Value Engineering Study

KY 15 - KY 28 to HADDIX

Item #10-285.00 and #10-286.00

Kentucky Transportation Cabinet (KTC)

N.E. RECOMMENDED

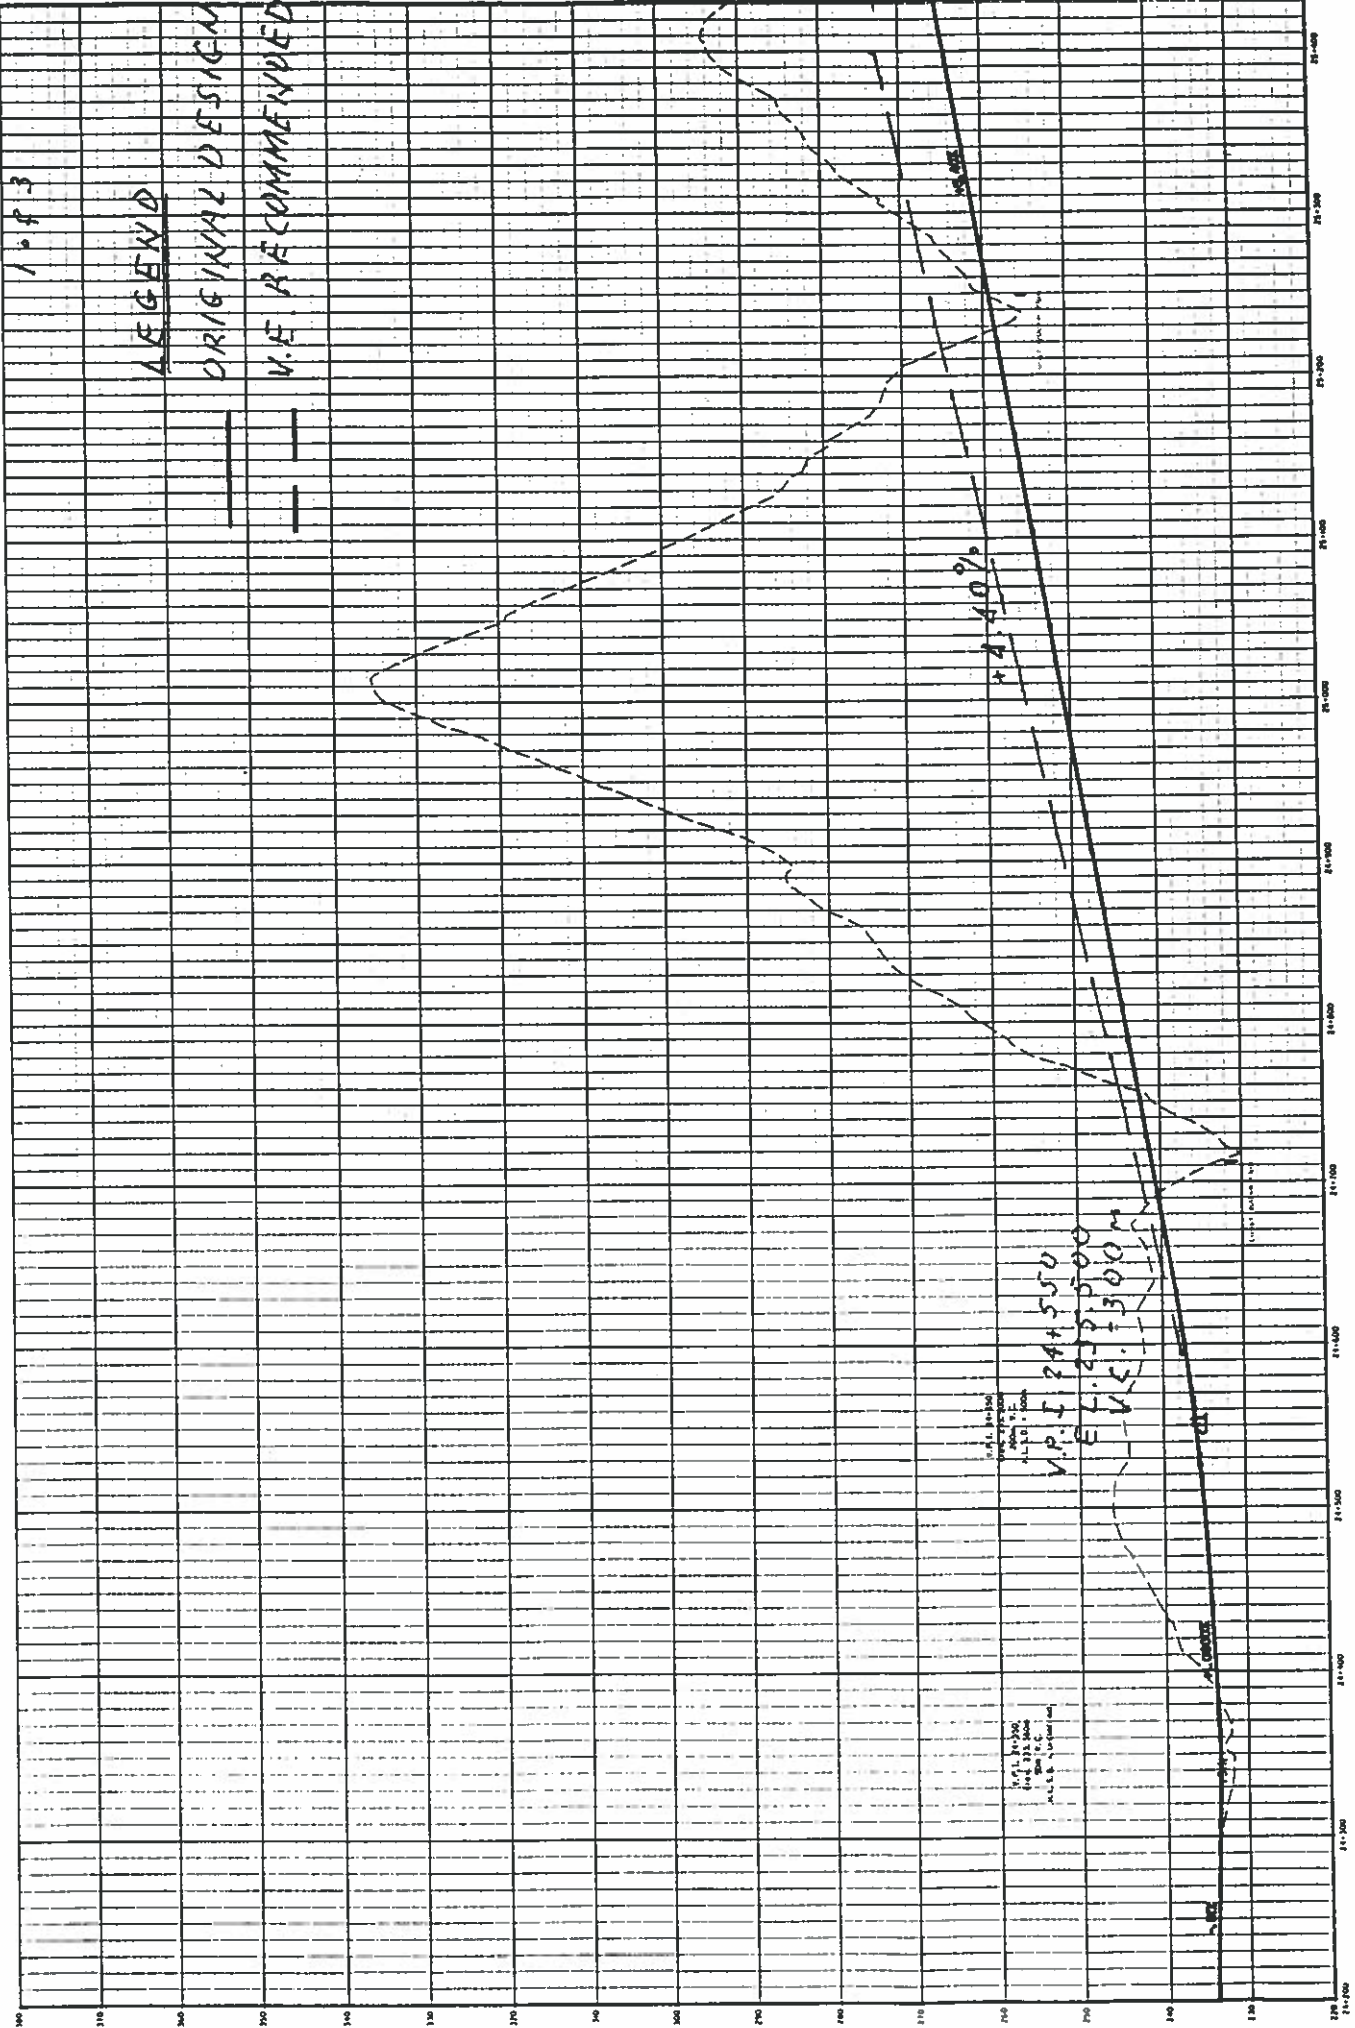
RECOMMENDED CHANGE: The VE Team recommends raising the grades through major cut areas to reduce the amount of roadway excavation quantities. The following areas have been selected because they are not constrained to follow the existing corridor.

Roadway Excavation constitutes 67% of total construction costs in the preliminary estimates. The VE team felt this could be reduced by changing grades in areas of the projects that were not constrained by the vertical alignment of the existing corridor. These areas were defined previously in this report. They are discussed separately below:

PROPOSAL 1A
FIGURE 2

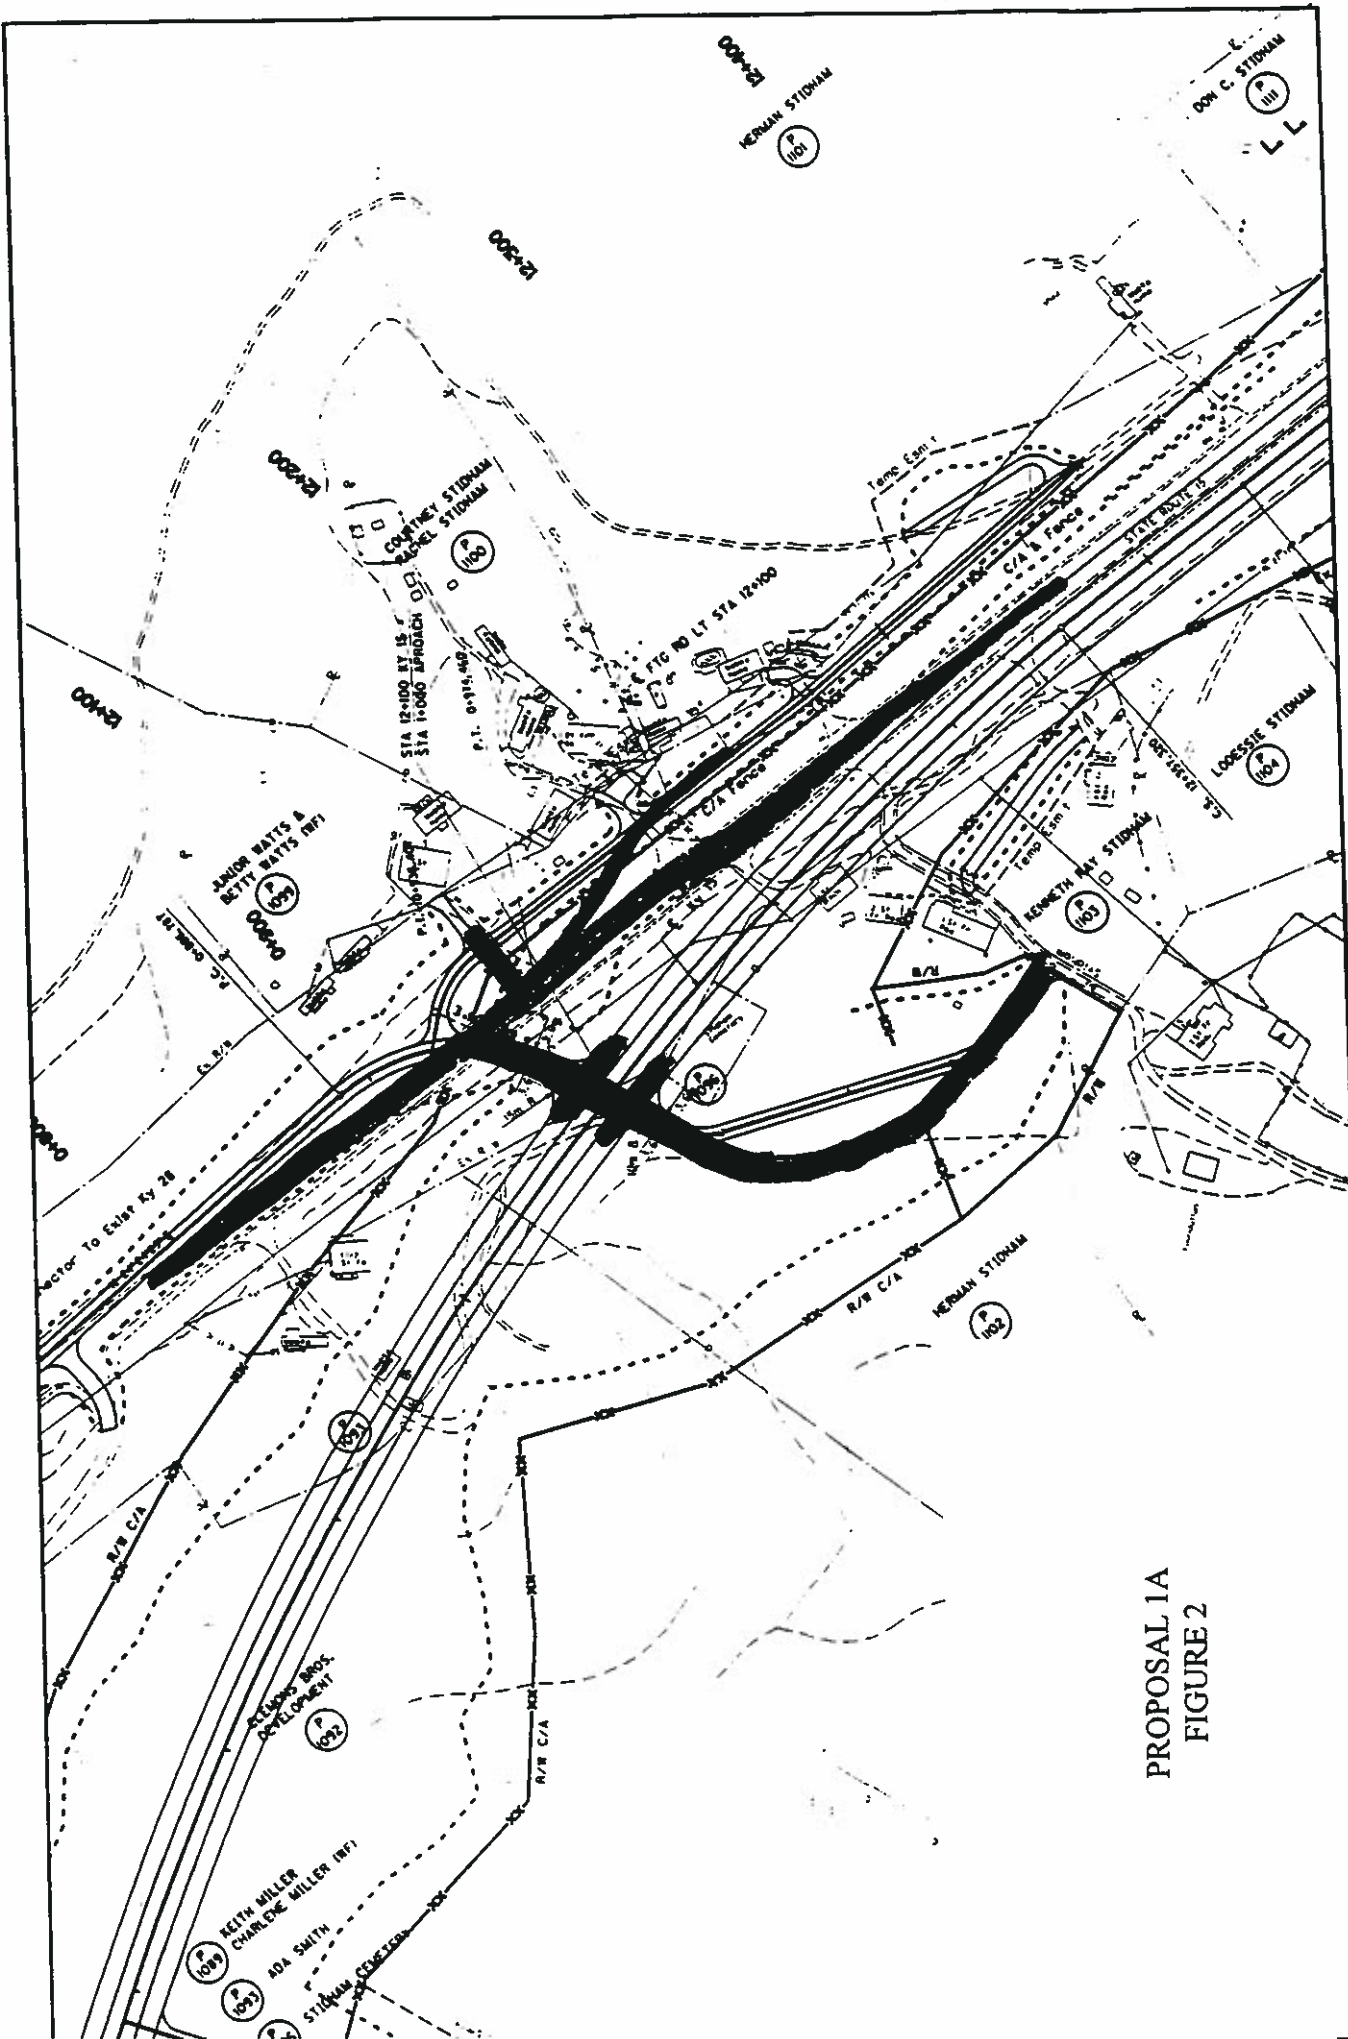
Area 1: Raising the grades in this area requires the modification of the at-grade intersections at approximate Station 10+500 and approximate Station 12+100 to separated-grade half-diamond intersections (see Figures 1 & 2). Following table summarizes an approximate vertical alignment. The final vertical alignment requires further study and evaluation.

REVISED TYPICAL SECTION

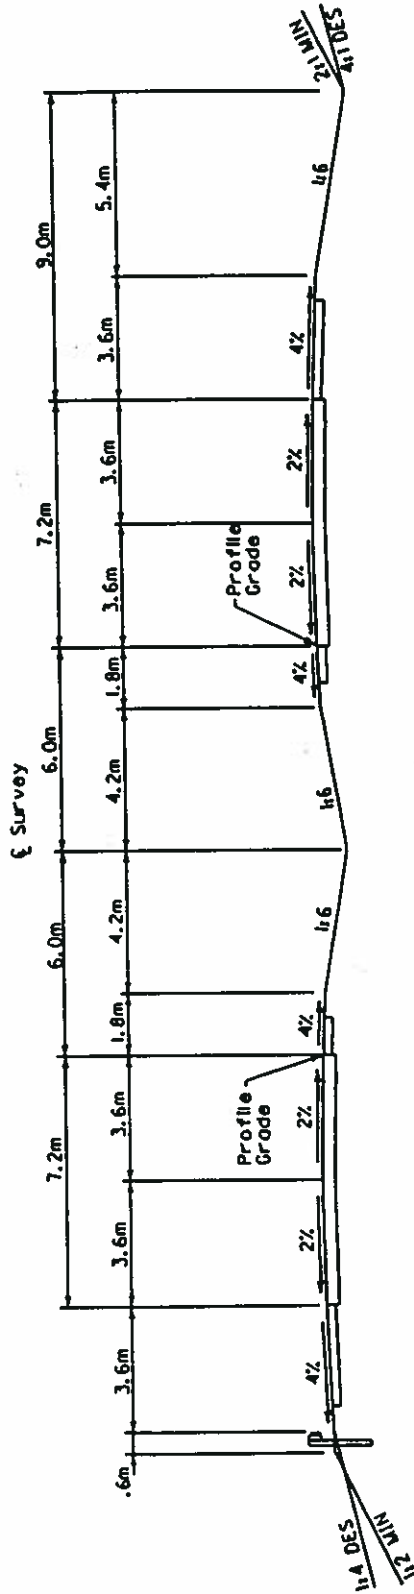
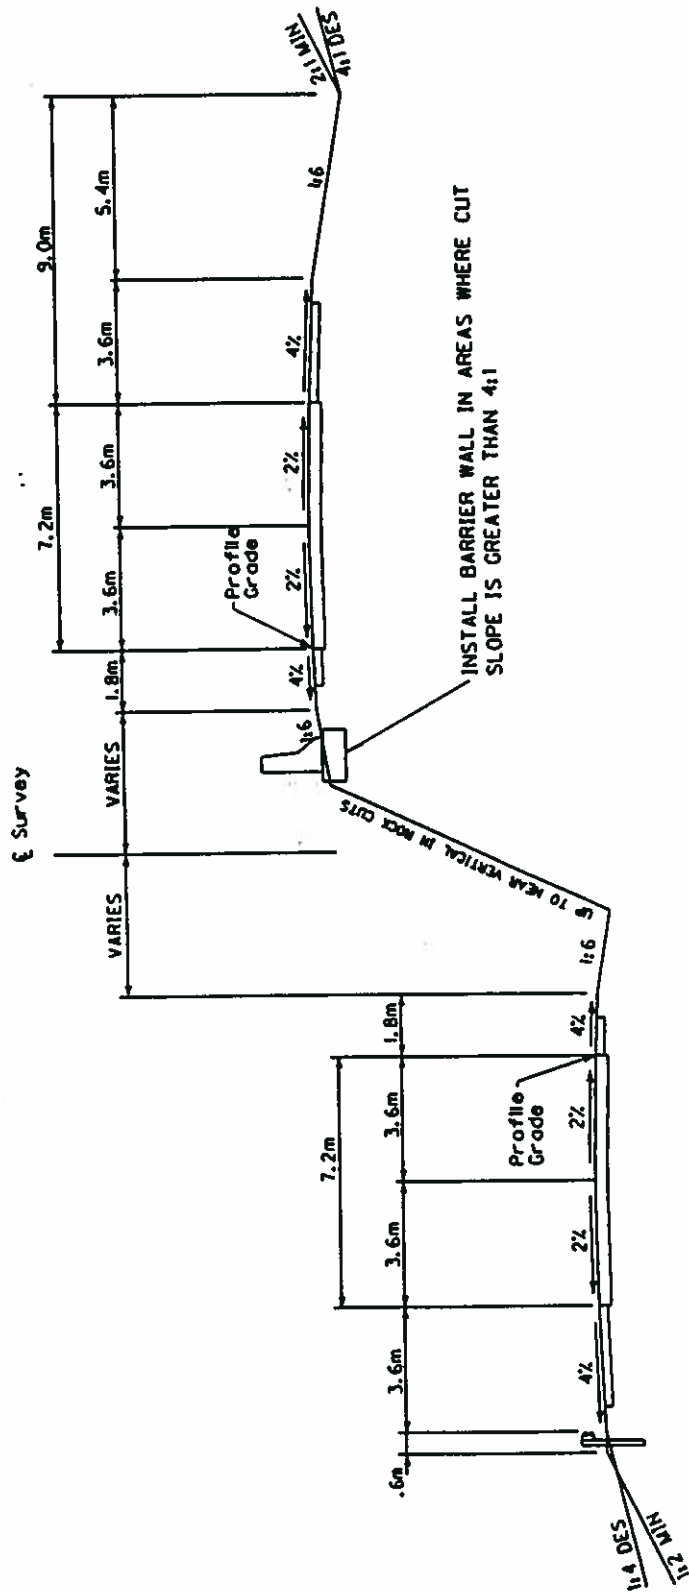
The proposed modification to the profile and alignment, which allows each half of the roadway to act somewhat independently of the other, will help to minimize the excavation on the project. With the excavation cost of the project being 67% of the total cost of the project, any means of reducing excavation will offer the potential for significant cost saving with no impact to the operation or safety of the proposed roadway.

The proposed modification, which should be considered for the areas of significant cut, can be accomplished while meeting the design standards of the Kentucky Transportation Cabinet. There are however several other potential modifications which must be considered when designing the bifurcated roadway:

ALTERNATE 3A - 30' MEDIAN

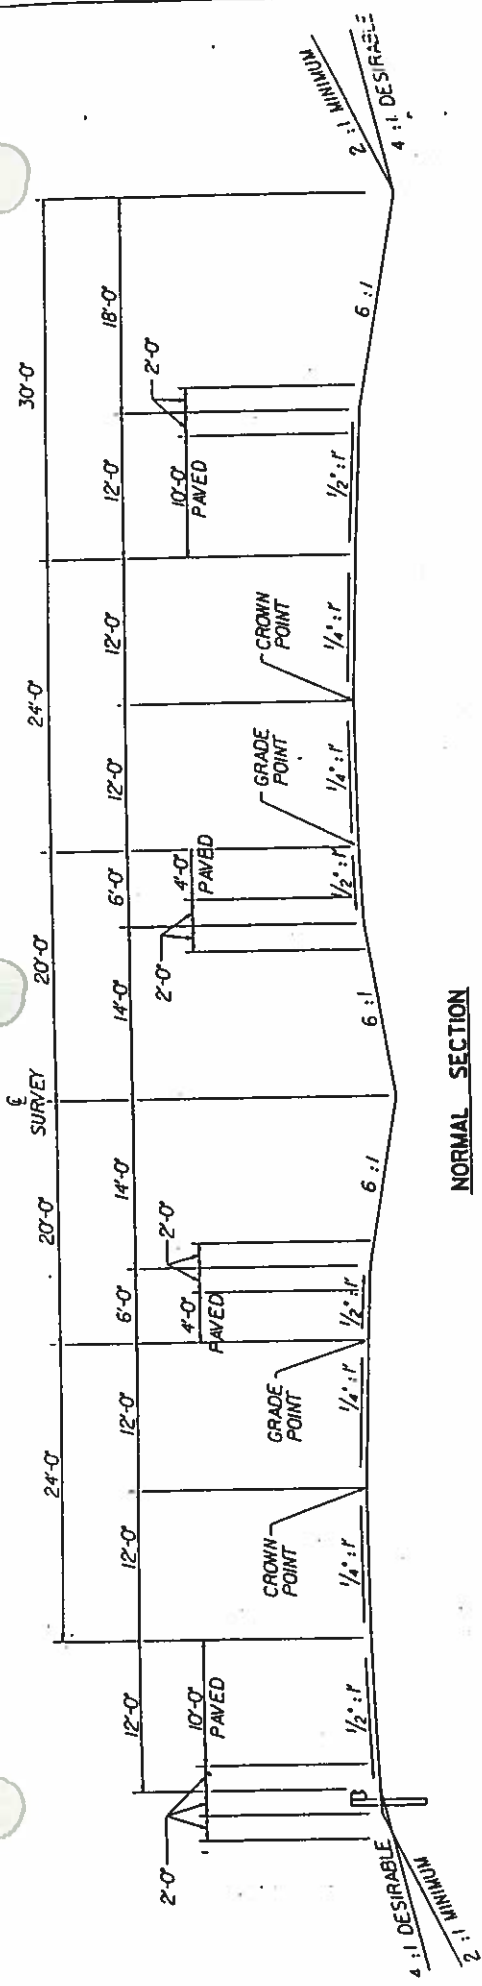
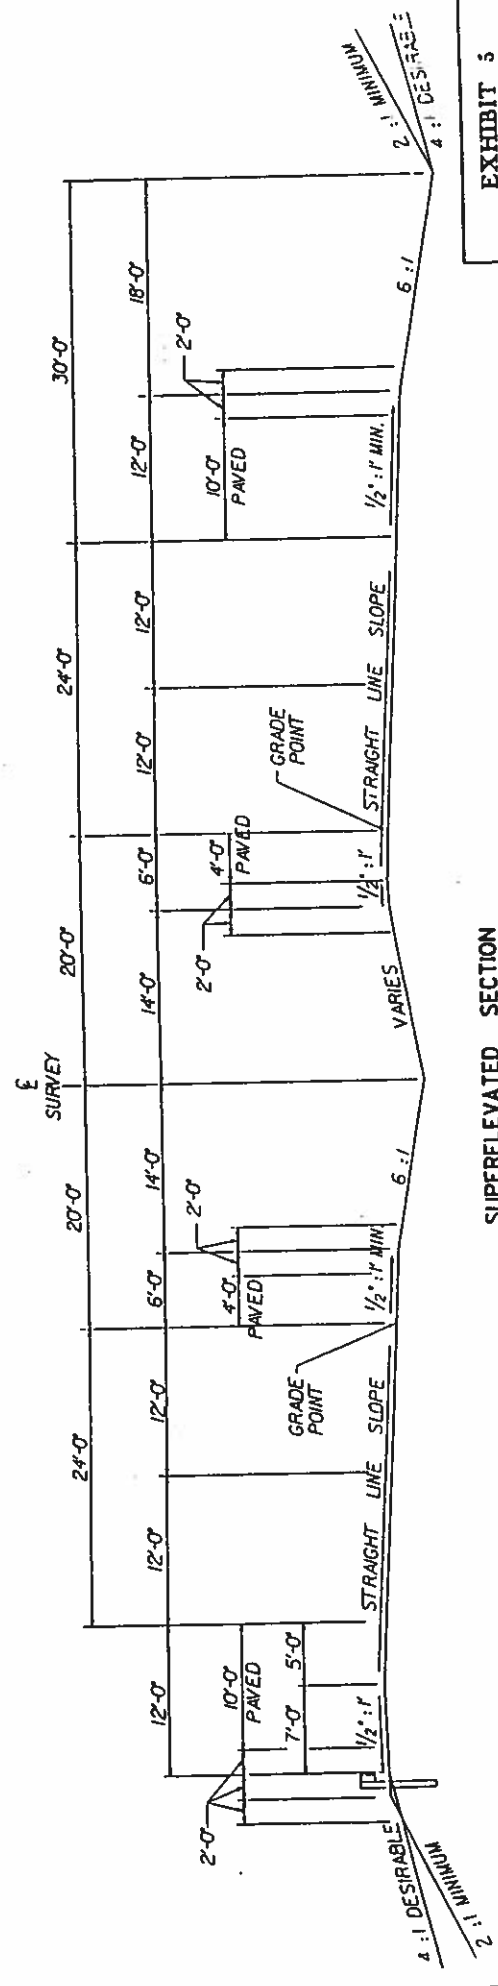
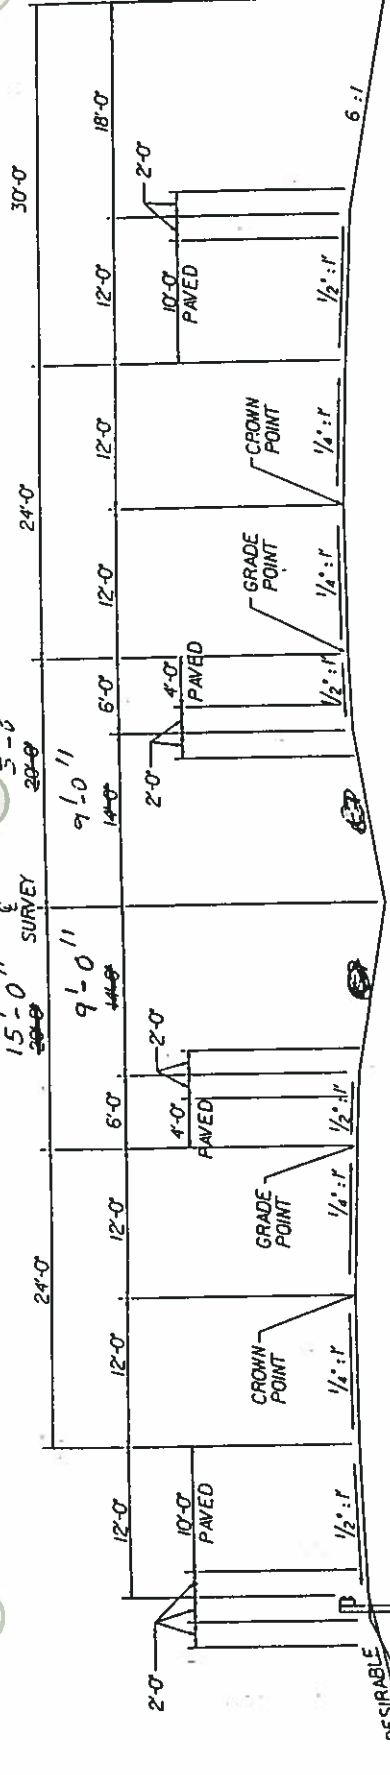
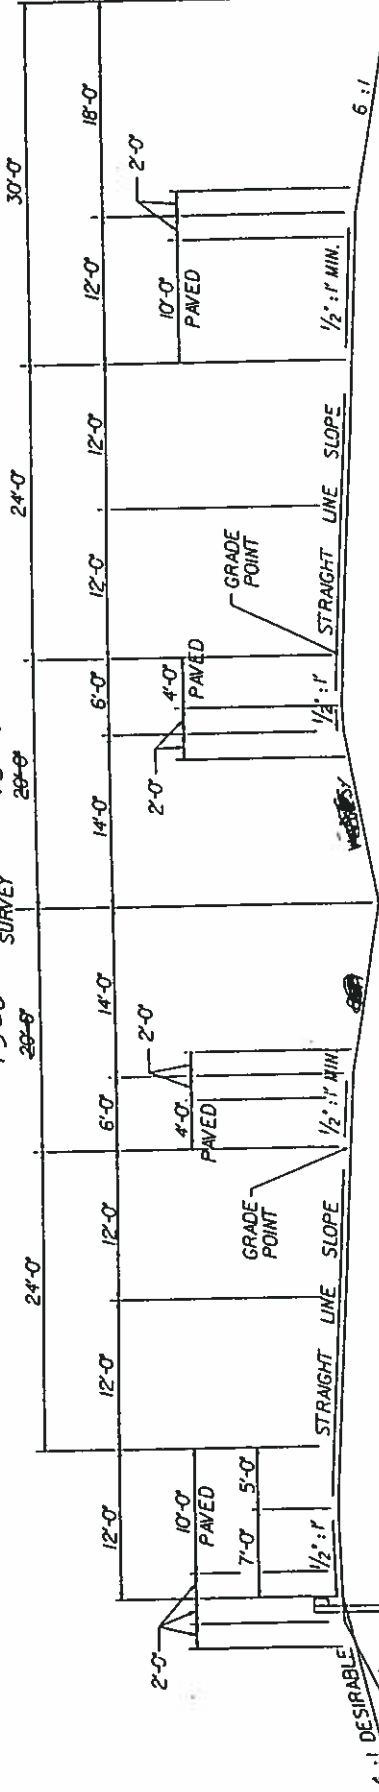
SAVINGS - $1,894,650 \times \$4 \text{ (CU.M.)} = 7,578,600$
EXCAVATION COST
